DATE: 9/24/2026

PROJECT: ATF Dayton Field Office Renovation
Phase 2

ADDENDUM NO. 2

FINISH SCHEDULES, WALL TYPES AND DETAILS

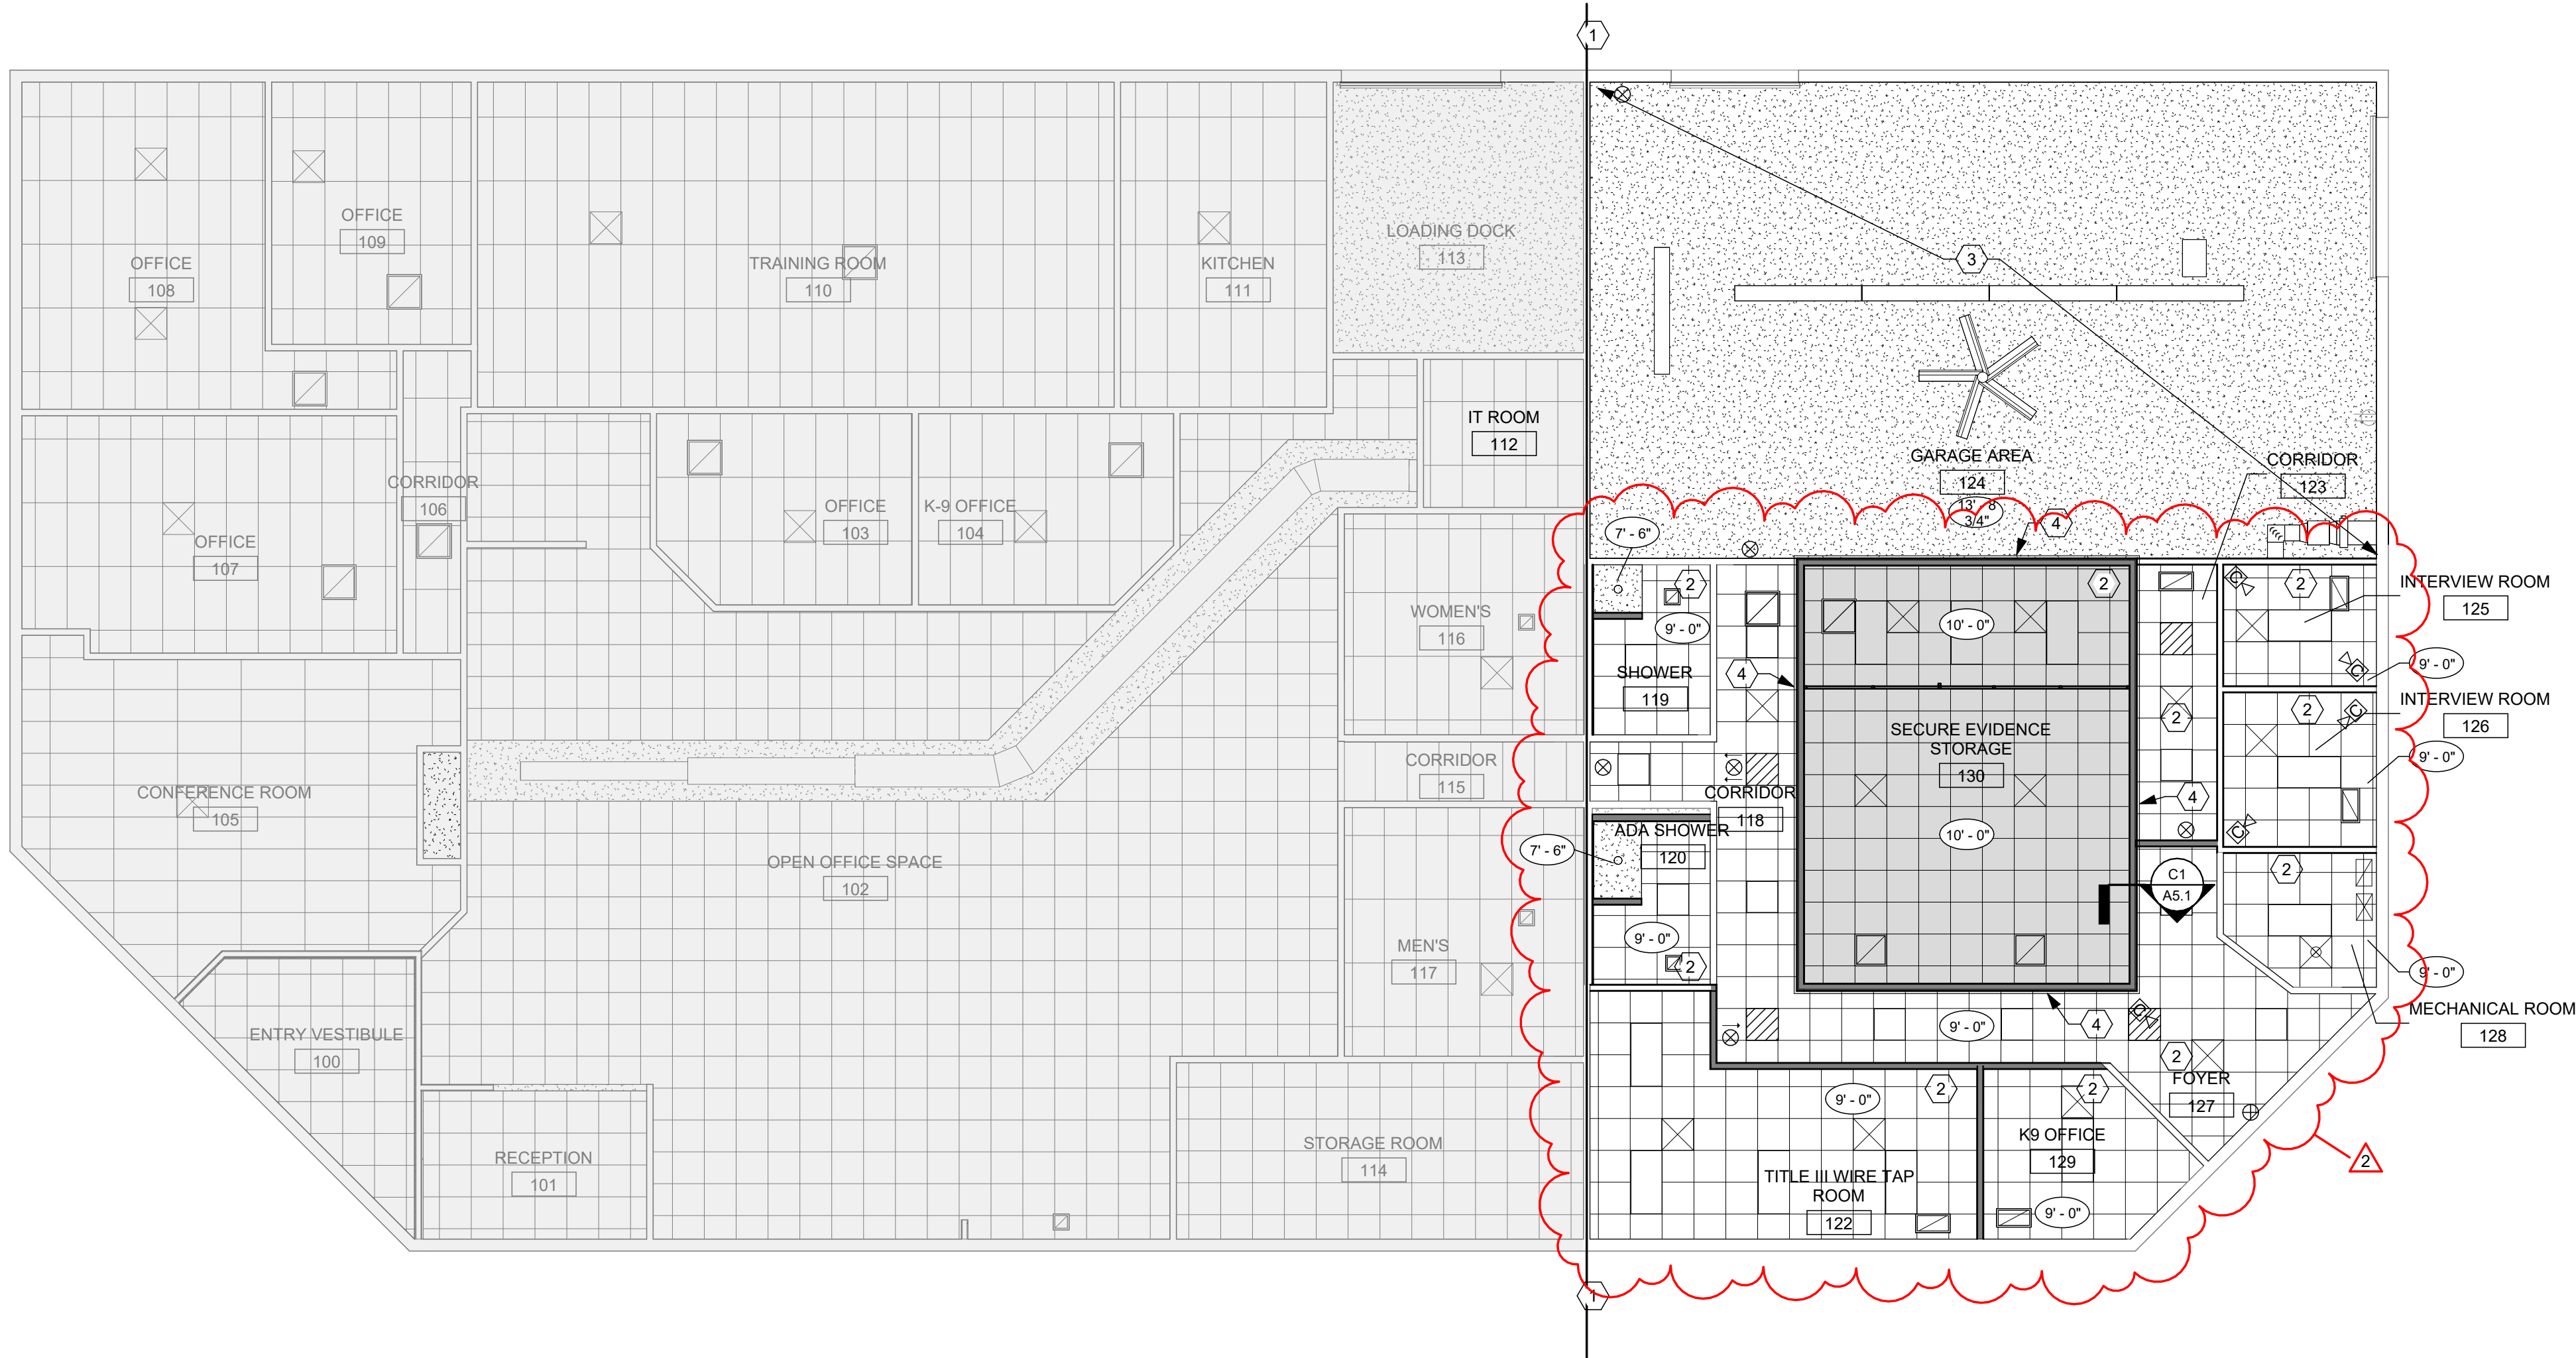
- ITEM A1: Sheet A0.2 – FINISH SCHEDULES, WALL TYPES AND DETAILS
1. Room Finish Schedule: Update ceiling material at rooms 119, 120, and 130.
 2. Material Legend: Update APC-1 material model number.
 3. Material Legend: Add APC-2.
- ITEM A2 Sheet A2.2 – REFLECTED CEILING PLAN
1. Update ceiling tile sizes.
